HALLIE HEIGHTS SUBDIVISION, TIF
35.219 ACRES
REVISED MASTER DEVELOPMENT PLAN

Re: Hallie Heights Subdivision (Amended)

MDP # 756-A TIF

The City Staff Development Review Committee has reviewed the Huebner Square Townhomes Development Plan, **M.D.P. # 756-A**. Enclosed, please find a signed copy for your files. Your plan was accepted however please note the following:

MDP OF
40.237 ACRES OF LAND
VOL. 9217, Pg. 753, OPRORP
CITY OF SAN ANTONIO,
BEXAR COUNTY, TEXAS

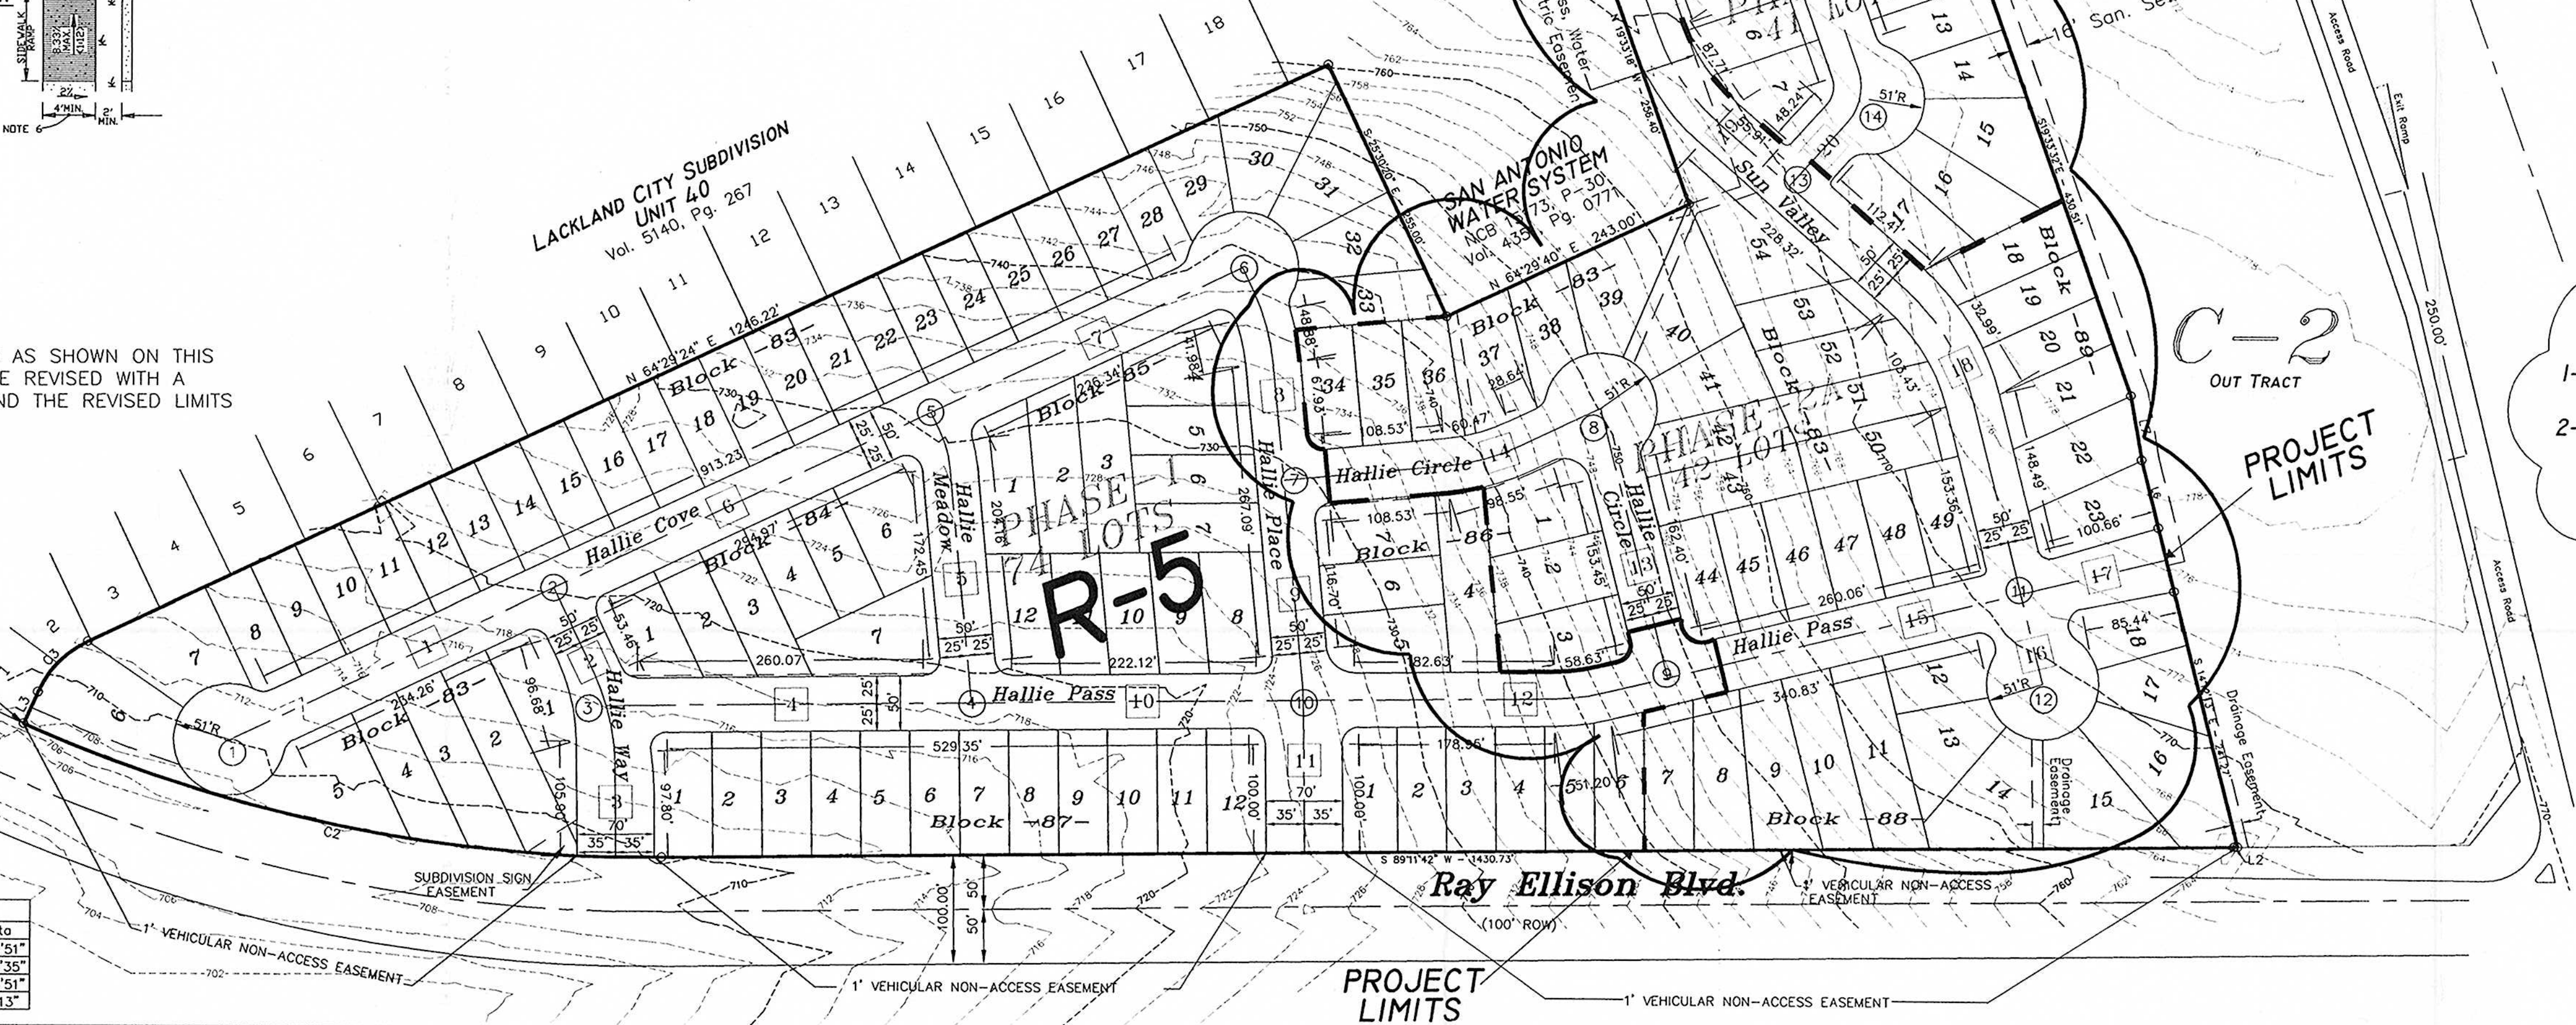
- In consideration of public safety and convenience, excessive grades by reason of topography should be avoided in street layouts and arrangements.
- Any access and R.O.W. issues along state facilities will need to be resolved with the **Texas Department of Transportation (TXDOT)**. For information about these requirements you can contact TXDOT at 615-5814.

1. The pavement designs shown shall not be utilized for plat review. Plat review requires standard geotechnical report.
2. Clear vision easements shall be provided in accordance with UDC 35-506(d)(5).
3. 15-foot property line returns shall be provided at all street intersections with Ray Ellison and Loop 410.
4. At the Loop 410 frontage road intersection, a right turn lane shall be provided for the new platted subdivision.

It should be understood that this is a general review of a conceptual plan not an in-depth review of internal and external traffic flow, nor streets and drainage plans. The internal street network shall be planned in order to provide safe and efficient movement of traffic to and from, within and past, the proposed development, while minimizing the impact to non-site trips. All technical requirements of the Unified Development Code will be complied with at the time of platting.

Parks and Recreation: Hallie Heights is a proposed subdivision of 203 residential lots. Per UDC section 35-503, table 503-1, the required Parks or Open Space requirement is 1 acre per 70 dwelling units. Phases 1 and 2 are vested. But Phase 3, consisting of 46 lots, is not and will have a requirement of .7 acres. A 0.2 acre parcel has been provided along with amenities.

- The 0.2 acre parcel being dedicated has 3 picnic units; a picnic unit is defined as a concrete or metal picnic table, and two benches permanently anchored to a concrete slab.
- A covered school bus stop is provided for use by the appropriate school district; a covered bus stop is defined as a concrete or metal bench, covered by a metal shelter permanently anchored to a concrete slab.
- Lighting for the parcel shall be provided.
